CHANGE ORDER

PROJECT NAME: Edward A. Dufresne Community Center CHANGE ORDER NO: 001
 PPG OCD-DR PROJECT NUMBER: 45PARA3201
 CONTRACTOR: Lamar Contractors, Inc. CONTRACT DATE: 12-7-11

Subject: St. Charles Parish- Community Center
Gustav/Ike Project Number 45PARA3201
Review of Construction Change Order No. 1

drawing number	ESK002
project number	21131.00
date	02-05-12
file name	1003201E601.dwg
issued for	this drawing modifies: E601

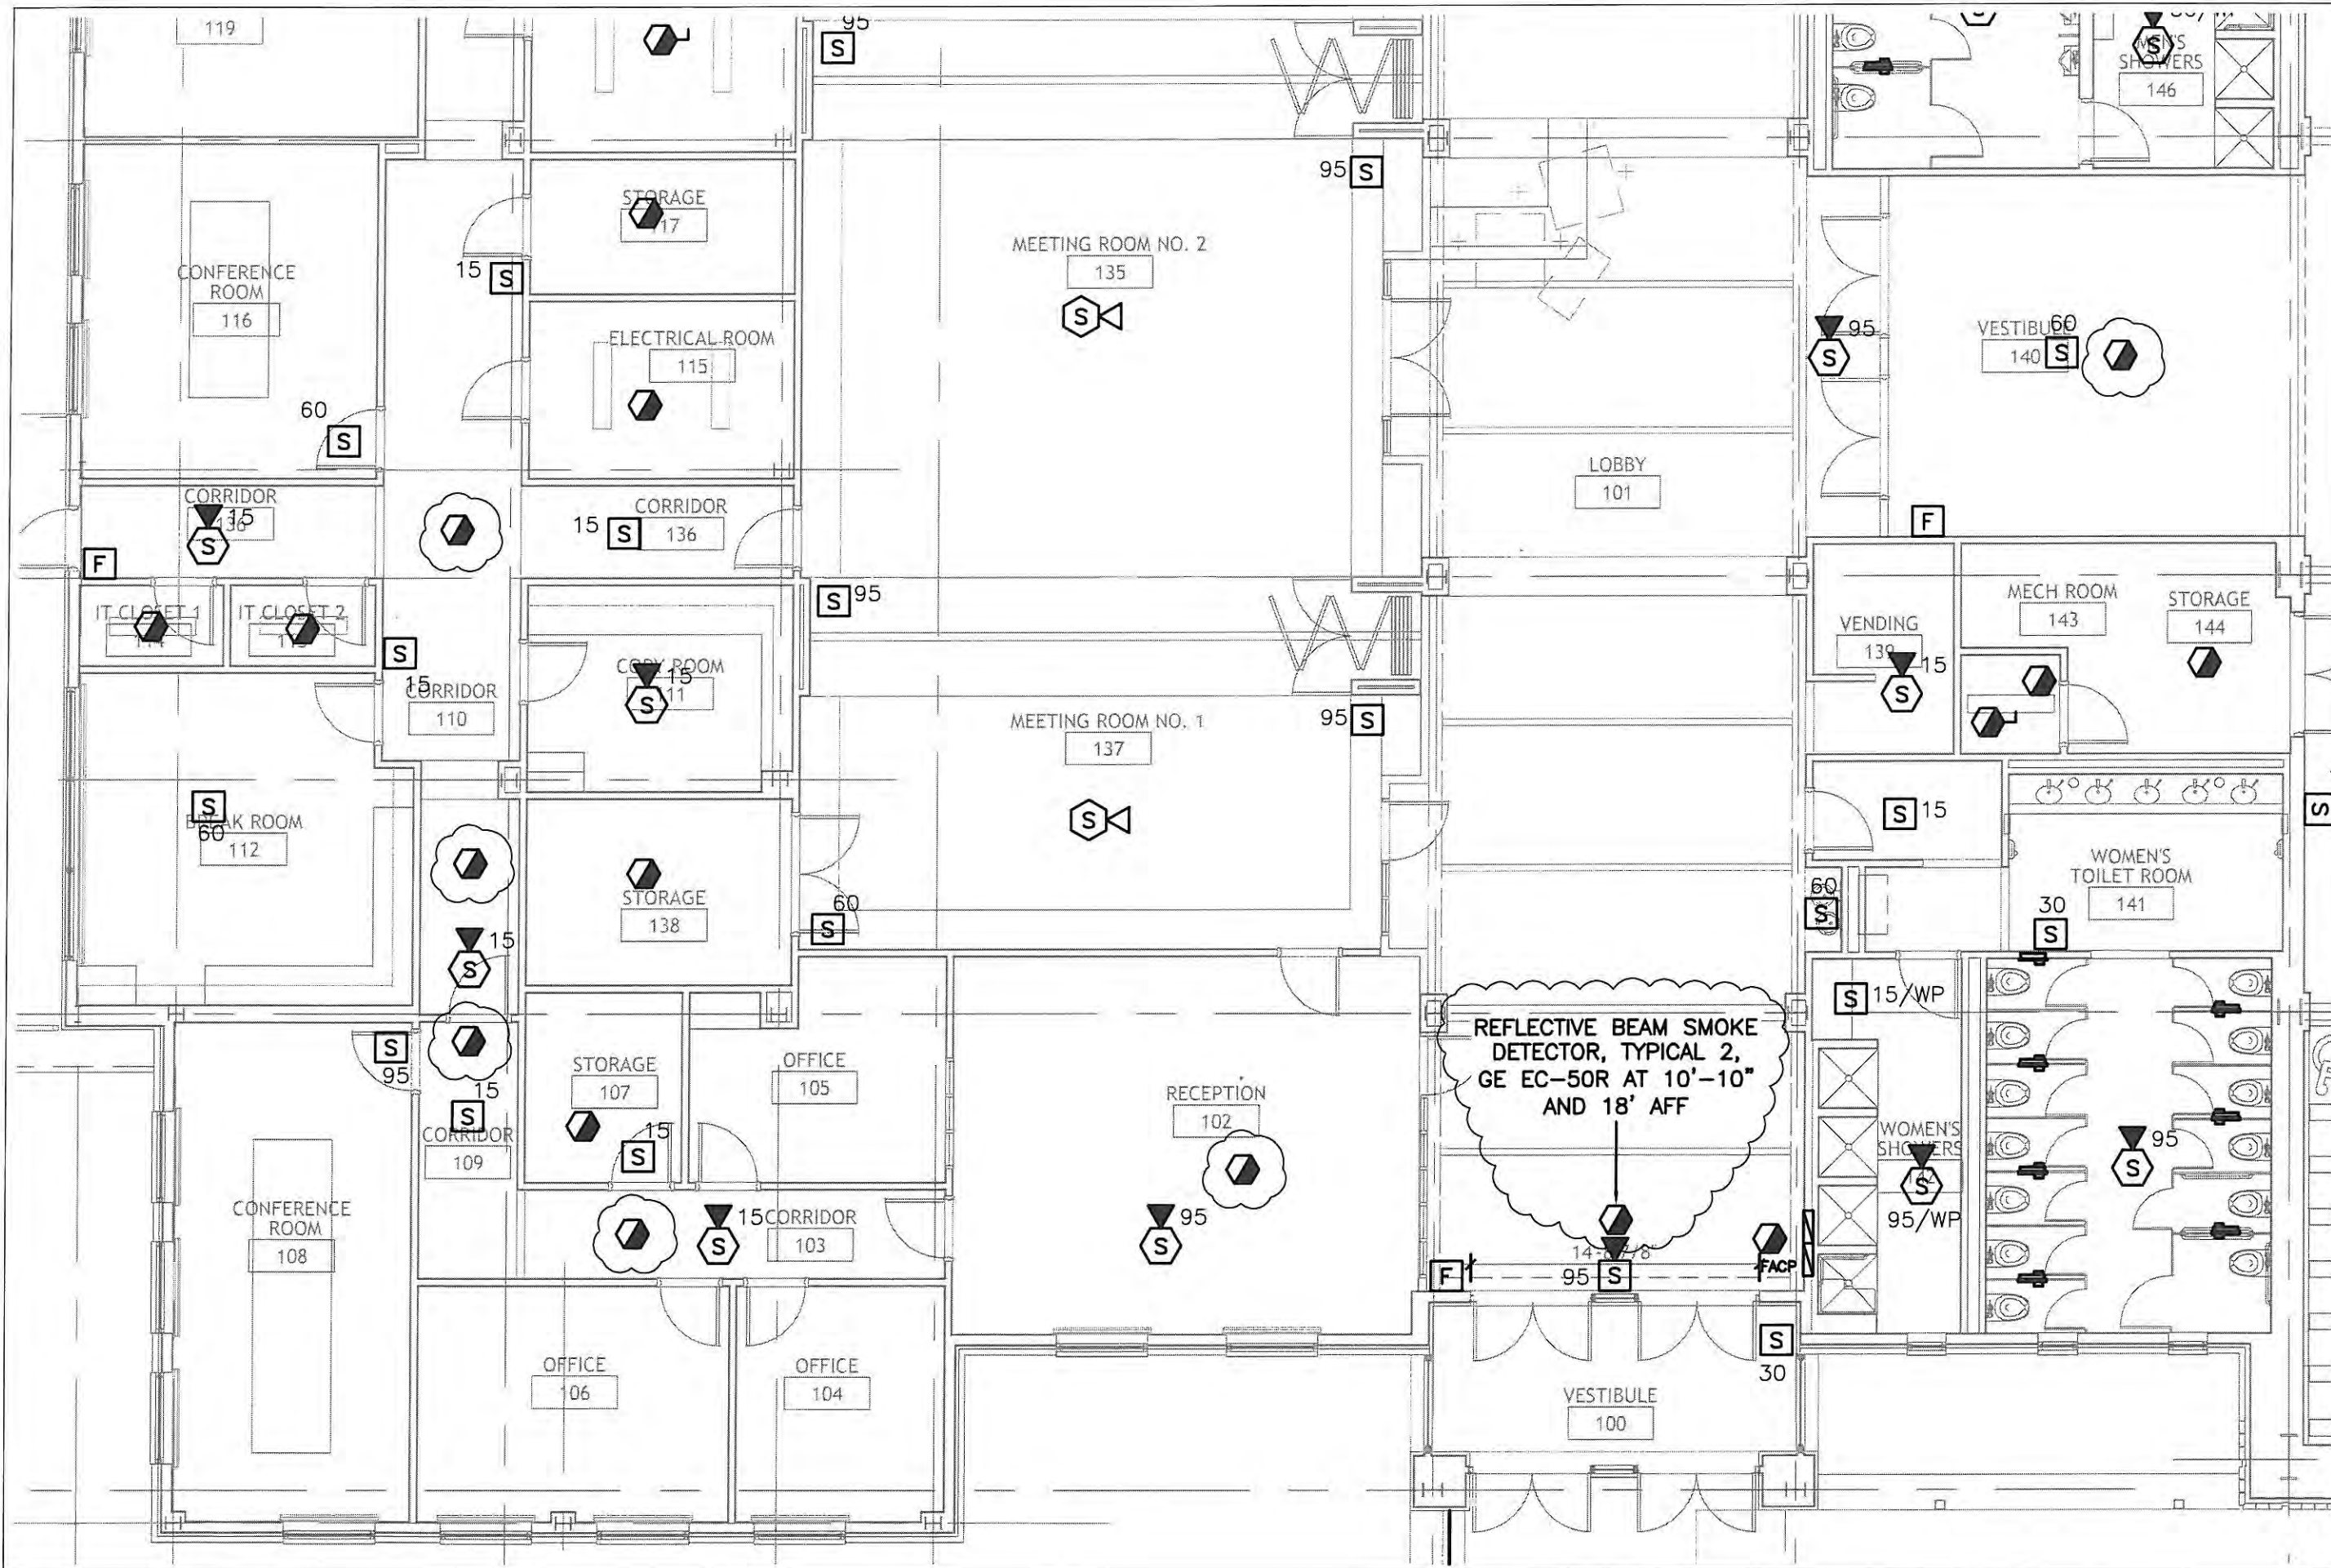
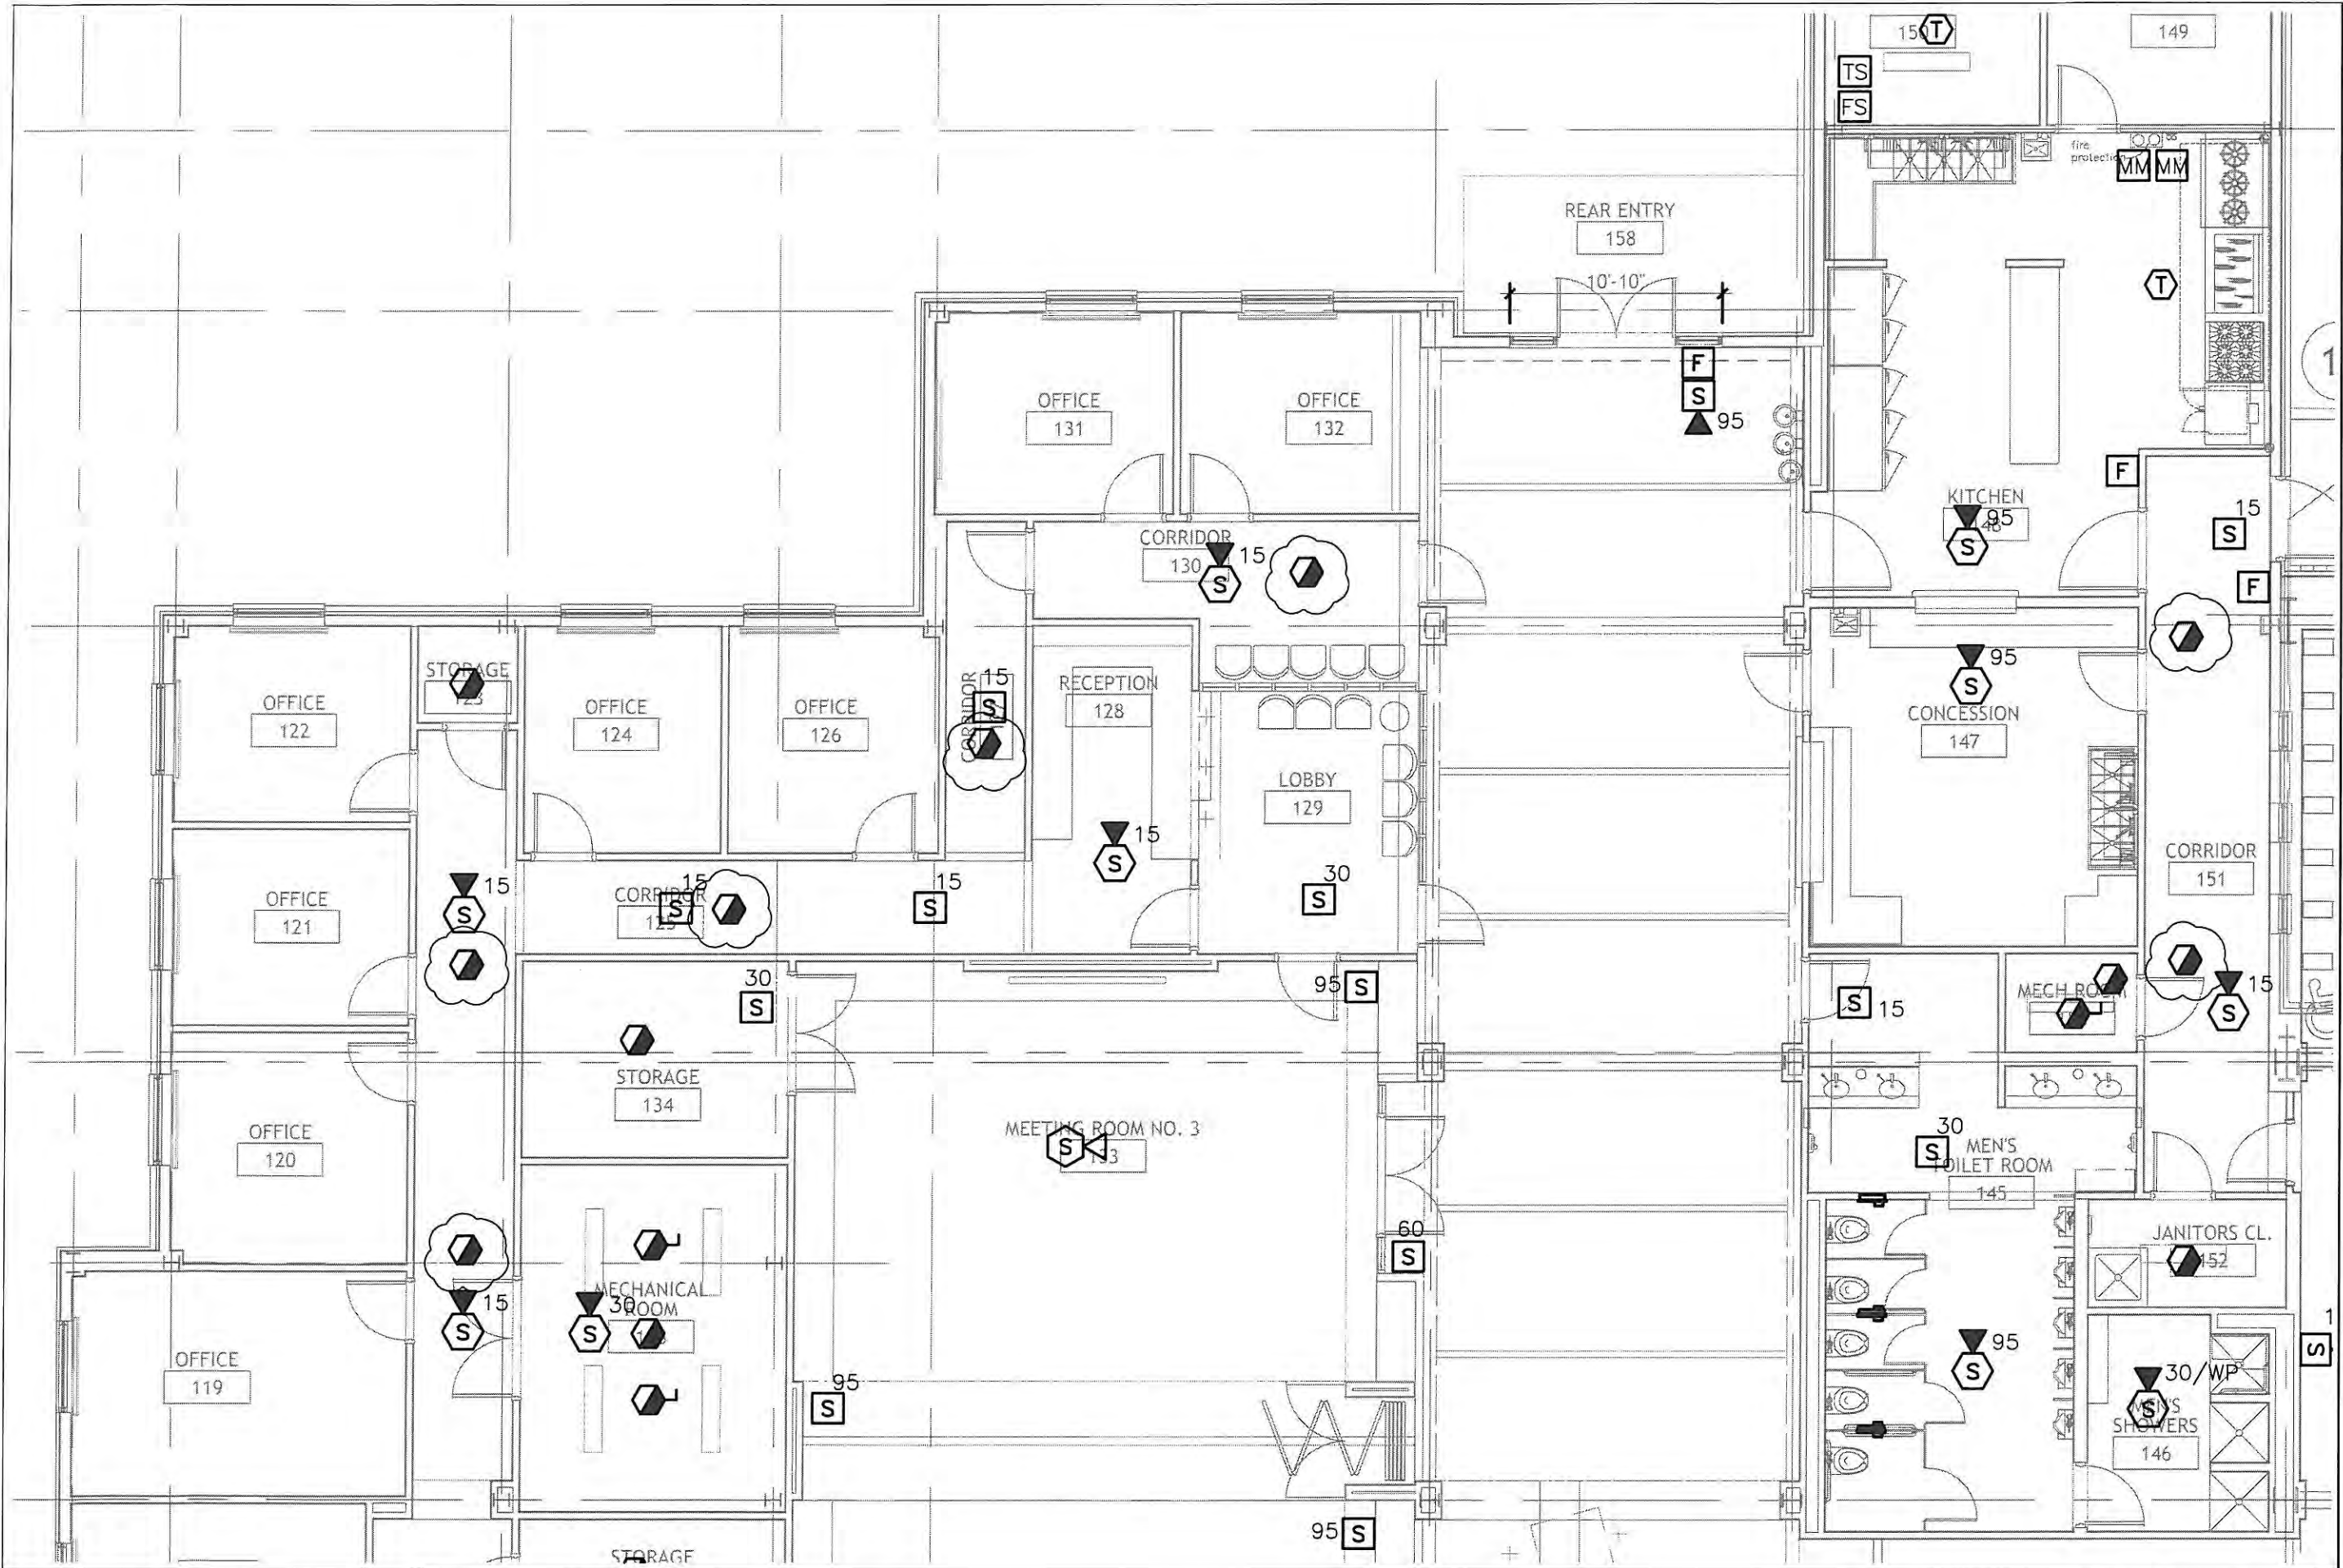
Install smoke detection devices as shown on attached sketches ESK002 and ESK003.

seal	file name 1003201E200.dwg	drawing number
	project number 21131.00	E200
	date 11-29-11	
	phase CA

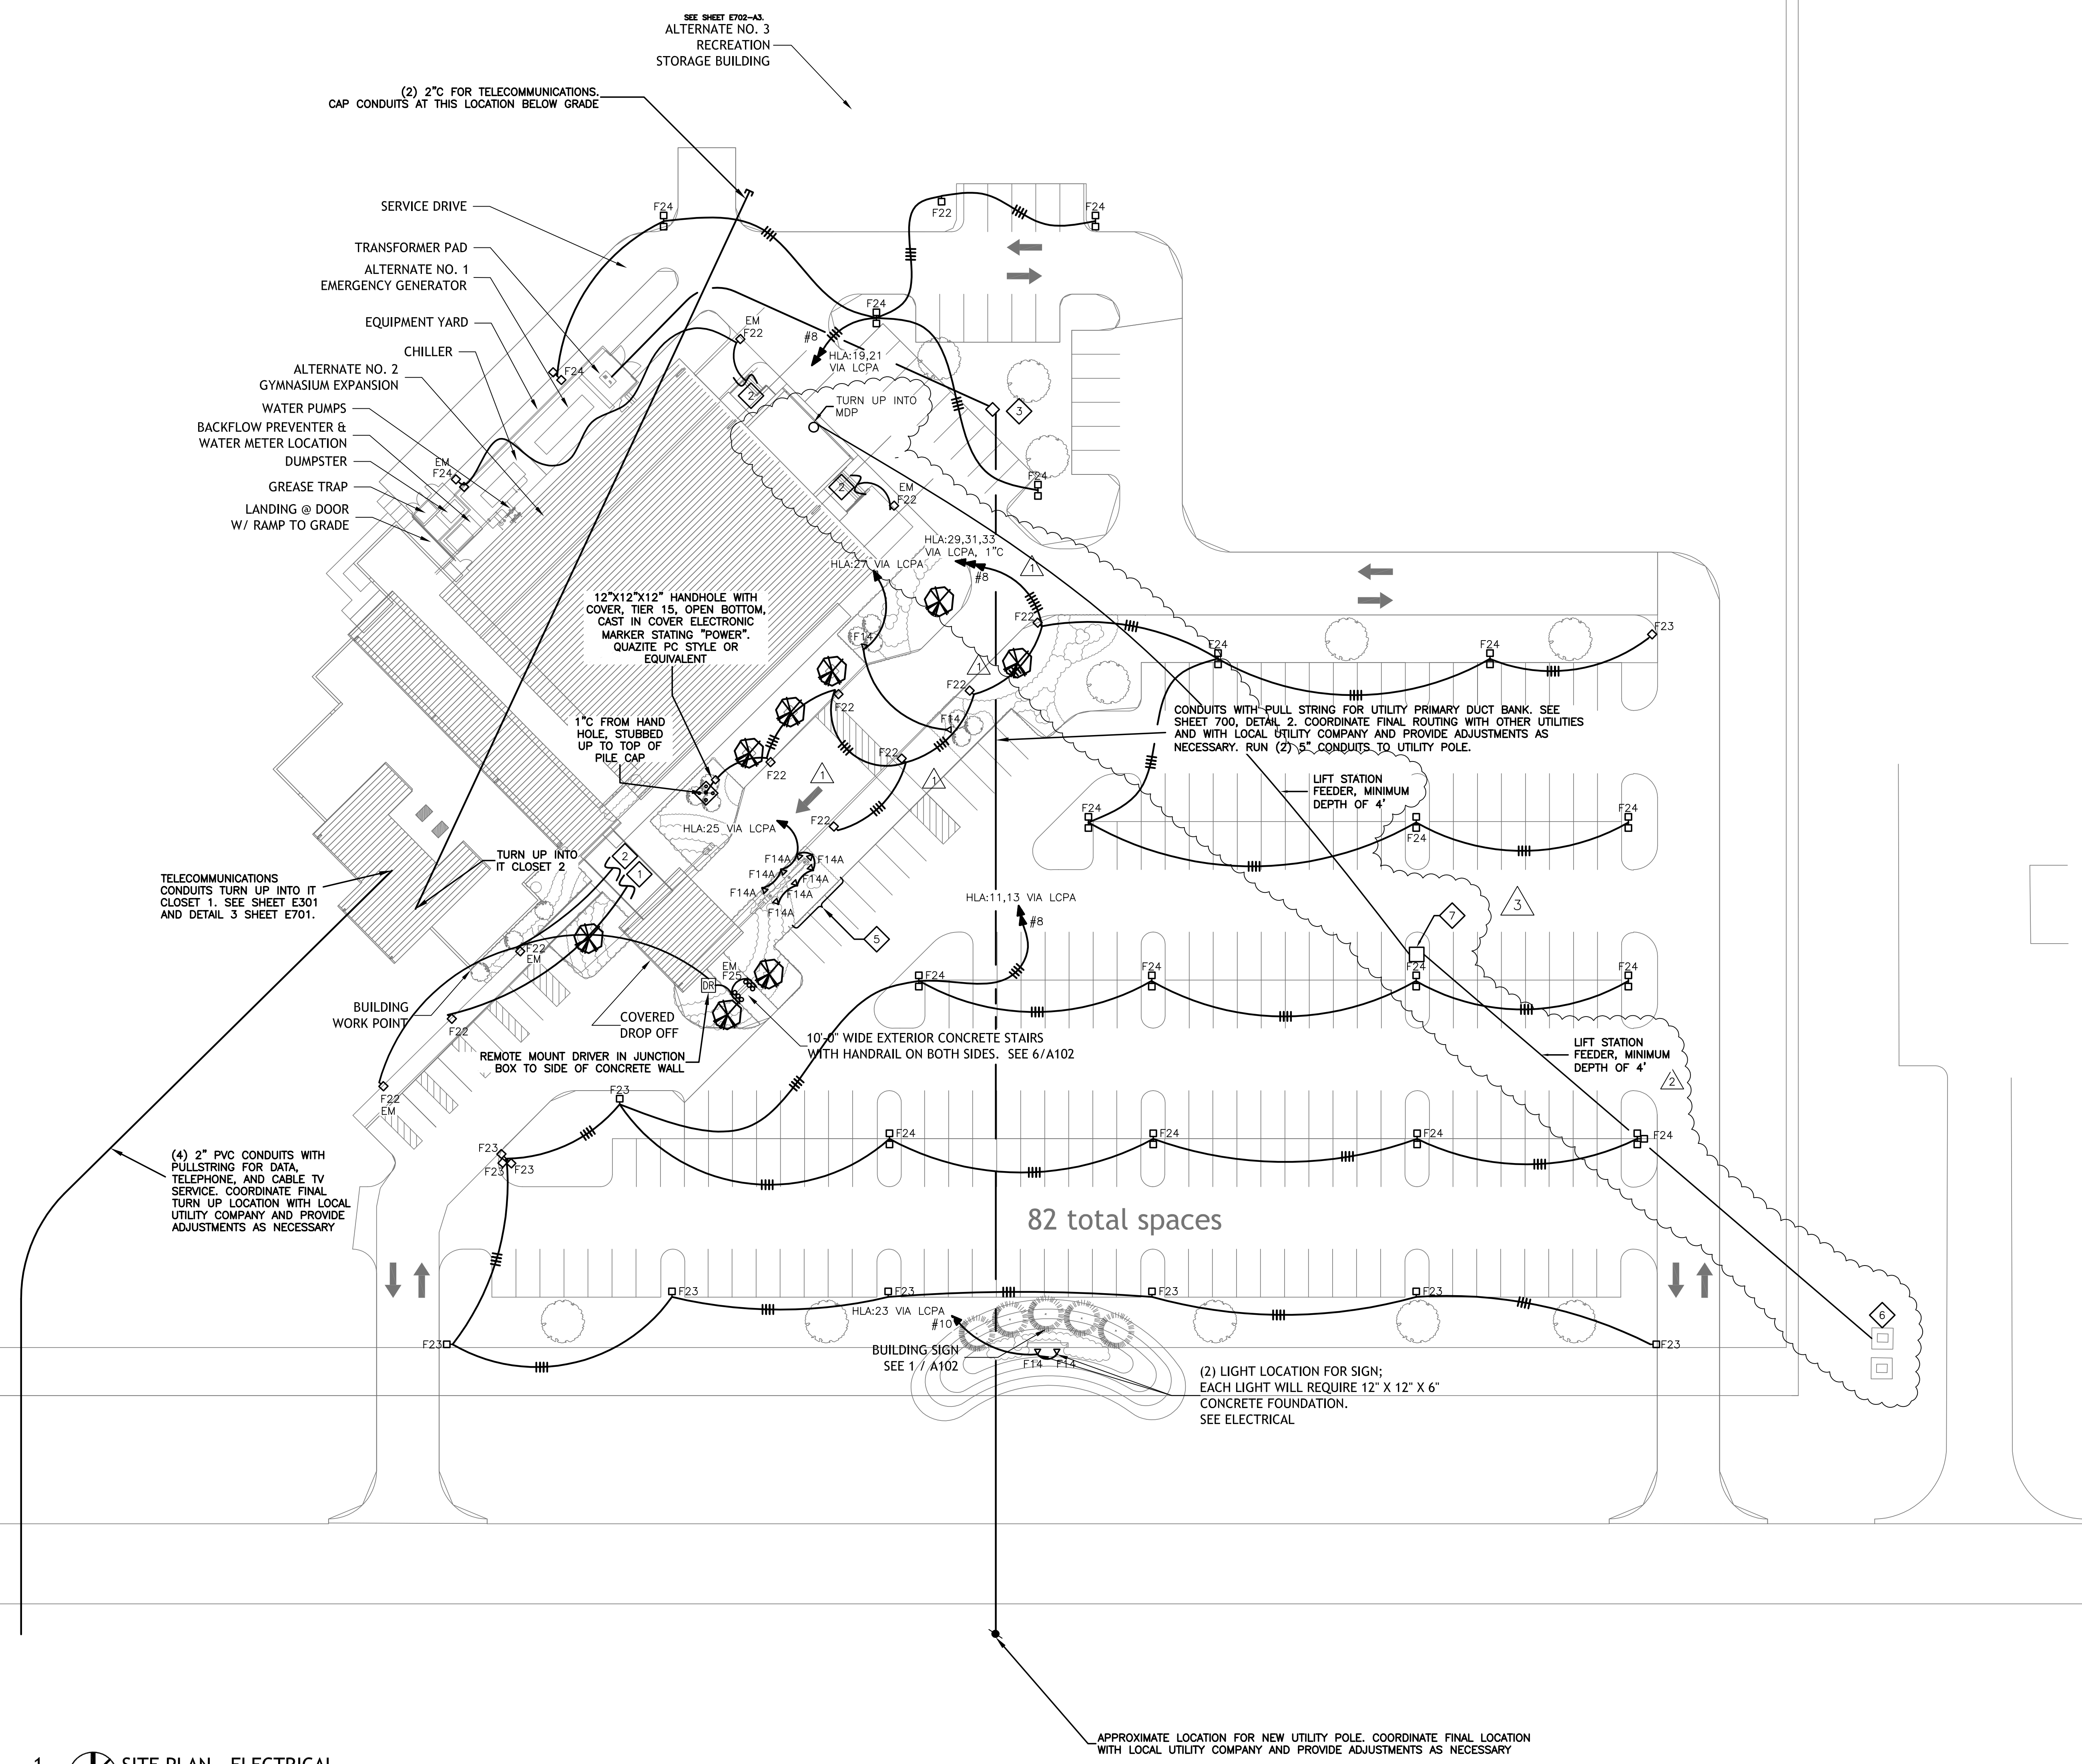
Per Owner's request, provide quote to install power to existing pumps at existing lift station along Edward A. Dufresne Parkway. Run electrical conduit and wiring from building's Main Electrical room 156 to existing lift station control panel as shown on attached reissued sheet E200 and sketch ESK004.
